9900 WILSHIRE PROJECT

Final Environmental Impact Report

Appendix D

Revised Project – Combination of Alternative 3, Reduced Density, and Variation B of Alternative 5B-1, 5, Modified Height and Configuration of North/South Buildings

FIGURE D-1

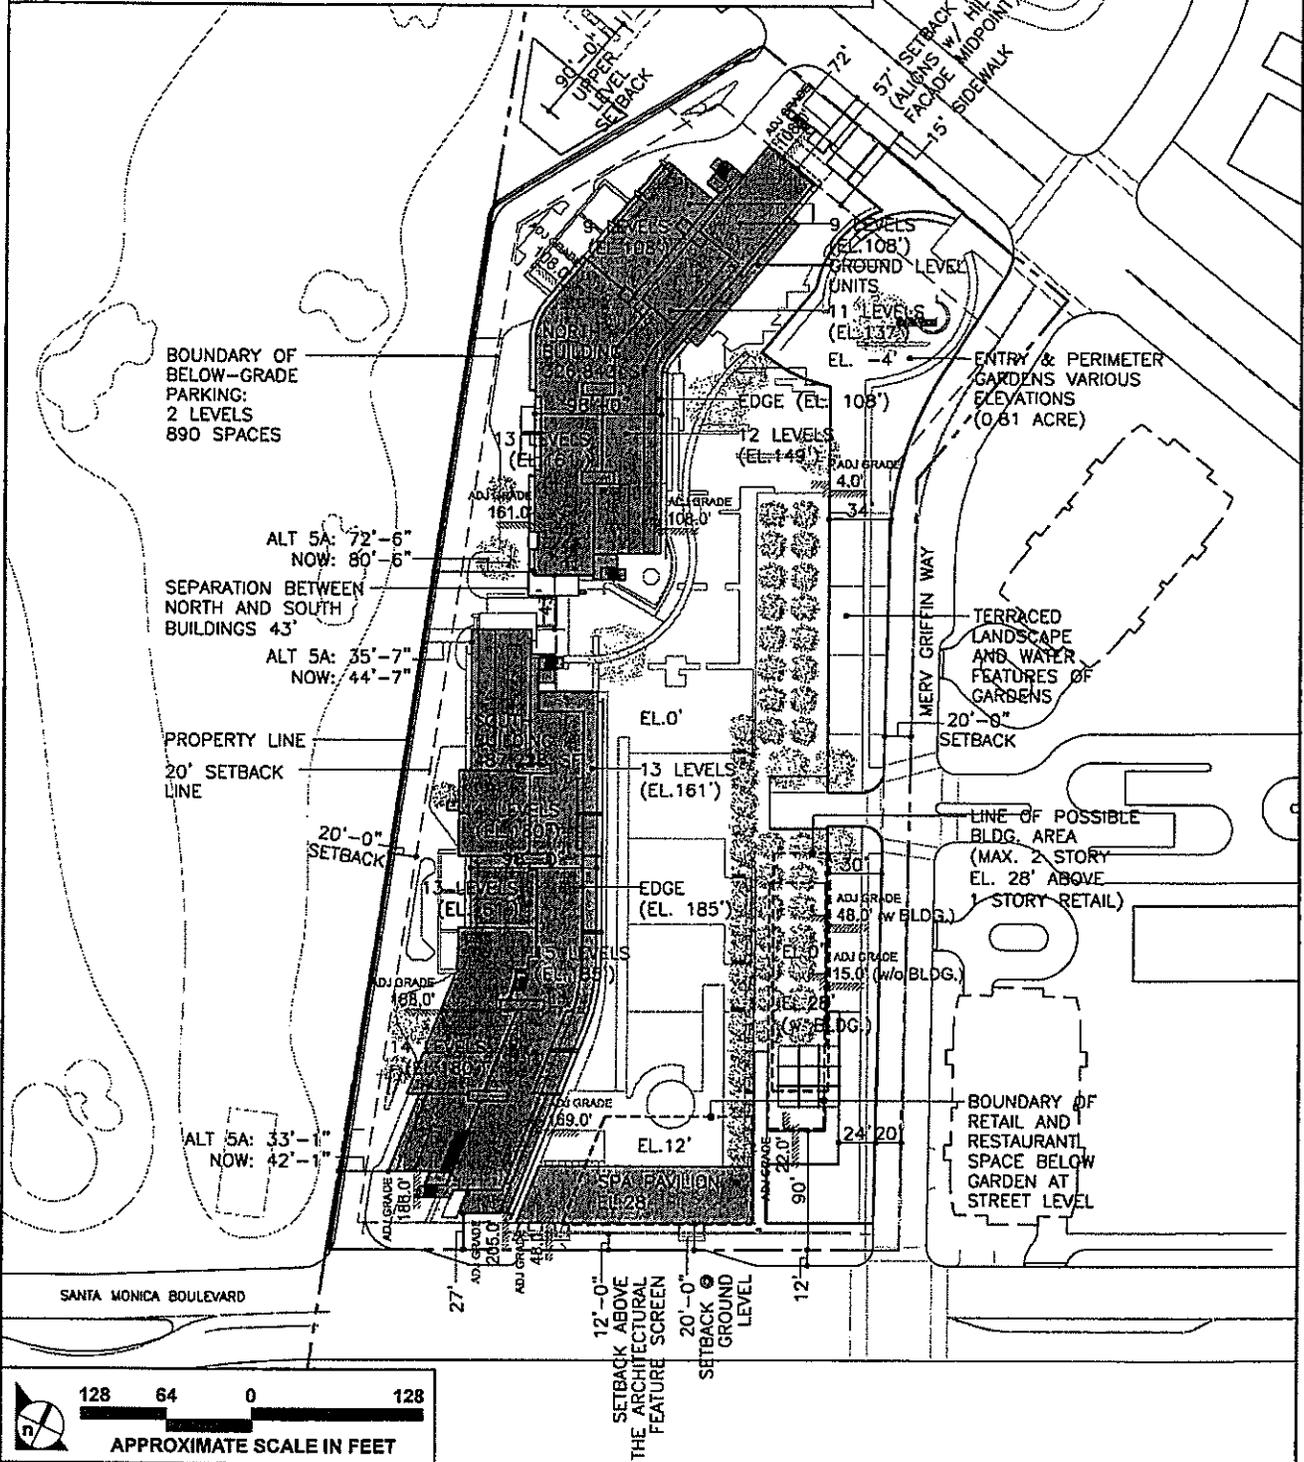
The Revised Project is a Combination of Alternative 3, Reduced Density, and Variation B of Alternative 5, Modified Height and Configuration of North/South Buildings. The Revised Project is shown in the **Revised Project Site Plan attached hereto**. A breakdown of the components of the Revised Project is provided in **Table D-1, The Revised Project, Combination of Alternative 3, Reduced Density, and Alternative 5, Modified Height and Configuration of North/South Buildings**.

For the Revised Project, the Applicant presented a project to the City Council that included 235 units in two buildings, a North Building and a South Building containing residences, a three-story retail building

with a spa on the top two floors at the southern end of the project, and a restaurant in a single-story building located in the southeastern corner of the site. At the request of the City Council, the Applicant agreed to remove approximately 8,000 residential square feet from the top ~~story~~two stories along the eastern elevation of the South Building. However, the City Council offered the Applicant the option of introducing up to four garden residences that would be located in a ~~single level~~two levels beginning on top of the northerly portion of the restaurant building, provided that there is no overall increase in the square-footage of the project. ~~Should the Applicant determine that it does want to add these garden residences, the Applicant may opt to remove up to 10,000 residential square feet from the South Building (including the 8,000 residential square feet removed at the City Council's request) and place it atop the restaurant.~~The addition would be approximately 120 feet in length and 40 feet in width. Regardless of whether or not the Applicant chooses to develop the garden residences, approximately 8,000 residential square feet would still be removed from the South Building. In the event that the Applicant does not incorporate the garden residences, that area will be ~~redesigned~~designed as a landscaped area intended to provide a greater sense of privacy for the private garden areas. An architectural feature such as a skylight or atrium would be featured above the restaurant as shown on the revised project site plan (Fig. D-1).

The Revised Project proposes 13 fewer residential units, ~~4,200~~4,000 fewer square feet of ~~retail and restaurant~~commercial uses, and an increased density of 0.12¹ (with a FAR of 2.63:1) compared to the original project. The Revised Project would eliminate the Loft Buildings, increase public open space by 0.39 acres, add a two story spa (exclusively for use by Project residents) above the one story commercial building at the southern end of the property and add up to 4 residential units (i.e., garden residences) on a second and third floor above the eastern restaurant proposed for the original Project.

The original project proposed to develop the North Building at height of 144 feet/12 stories. Under the Revised Project, the North Building has increased articulation and modulation of the eastern elevation and roofline, with building height stepbacks increasing with distance from Wilshire Boulevard and Merv

Griffin Way. Moving south from Wilshire, buildings height step up in increments from 108 feet/9 stories, to 137 feet/11 stories, to 149 feet/12 stories, and finally to 161 feet/13 stories at the southwest corner of the building.

The original project proposed to develop the South Building at a single height of 144 feet/12 stories. Under the Revised Project, the heights of the South Building would be stepped back and up moving away from the site's western boundary, which is coterminous with the Los Angeles Country Club's South Course. The portion of the South Building nearest the western boundary would alternate between 161 feet/13 stories and 180 feet/14 stories high, while the height of the eastern elevation would be 185 feet/15 stories— and 161 feet/13 stories.

Finally, the setback of the North Building would increase to 72 feet from the existing curb, which is 57 feet from the sidewalk on Wilshire Boulevard, to match the mid-wall setback of The Beverly Hilton's Wilshire Tower. The South Building would be set back 27 feet from the existing Santa Monica Boulevard curb. Additionally, the south end of the North Building would be set back 80.5 feet from the Los Angeles Country Club (LACC). The retail building would be set back 20 feet from Santa Monica Boulevard, and the restaurant building would be set back 24 to 30 feet from Merv Griffin Way. The separation between the North and South Buildings would decrease from 45 feet to 43 feet at its narrowest point as compared to the original project, but because of increased building articulation and modification of the North Building under The Revised Project, the separation would be as much as 105 feet in places. Further the setbacks of the North and South Building from the western property line in the original project were increased substantially in the Revised Project. Specifically, the North building setback was increased from 72' 6" to 80' 6" at the southern end of that building, and the South Building setback was increased from 35' 7" to 44' 7" at the north end of the South Building and 33' 1" to 42' 1" at the south end of the building closest to Santa Monica Boulevard.
